Access Compliance Report

Public Rights-of-Way

Intersection ID: 54454	Main Street: COLLINGHAM_DR	Cross Street: STEELE_CREEK_RD	Location: NW
ADA ID: 80761DBC4AA6	Ramp Type: Perp	Initial Pass/Fail: Fail	Overall Compliance: No
Severity Score: 12.5			
Codes/Mitigation Info/Possible Solution		Field Measurements/Component Compliance

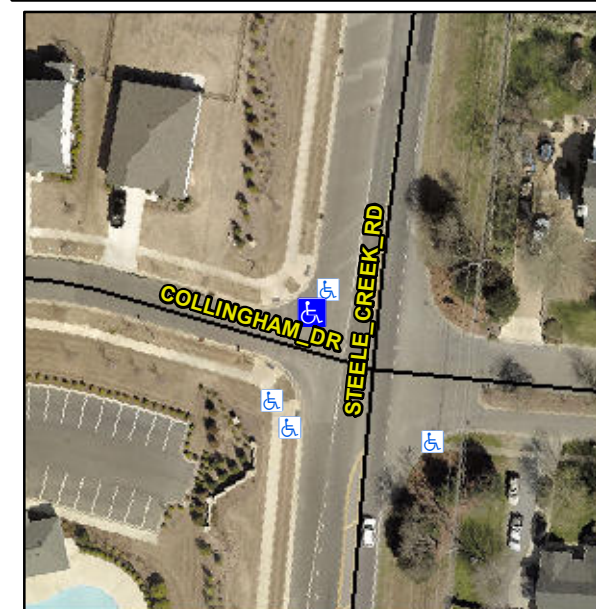
R304.2.2

Compliance	Description	Data	Compliance	Description	Data
N/A	Ramp Length (in)	101.0	No	Ramp Slope (%)	10.2
Yes	Ramp Width (in)	56.0	Yes	Ramp XSlope (%)	0.1
N/A	Flare Type LT	N/A	N/A	Flare Type RT	N/A
N/A	Flare Slope LT (%)	N/A	N/A	Flare Slope RT (%)	N/A
N/A	Flare Traversable LT?	N/A	N/A	Flare Traversable RT?	N/A
N/A	Landing Length (in)	N/A	N/A	DWS Provided?	N/A
N/A	Landing Width (in)	N/A	N/A	DWS Contrast?	N/A
N/A	Landing Slope (%)	N/A	N/A	DWS Length (in)	N/A
N/A	Landing X Slope (%)	N/A	N/A	DWS Full Width?	N/A
N/A	Landing Curb? (Y/N)	N/A	N/A	DWS Offset (in)	N/A
N/A	Shared Landing?	N/A			
N/A	Gutter Ponding?	N/A	N/A	Gutter Slope (%)	N/A
N/A	Gutter Lip Ht (in)	2.0	N/A	Gutter X Slope (%)	N/A
N/A	Painted X Walk1?	No	N/A	Painted X Walk2?	N/A
	X Walk 1 Direction	To SW		X Walk 2 Direction	N/A
N/A	X Walk 1 Width (in)	N/A	N/A	X Walk 2 Width (in)	N/A
	X Walk 1 Slope (%)	0.6		X Walk 2 Slope (%)	N/A
	X Walk 1 X Slope (%)	1.2		X Walk 2 X Slope (%)	N/A

Remove & Replace Entire Ramp.
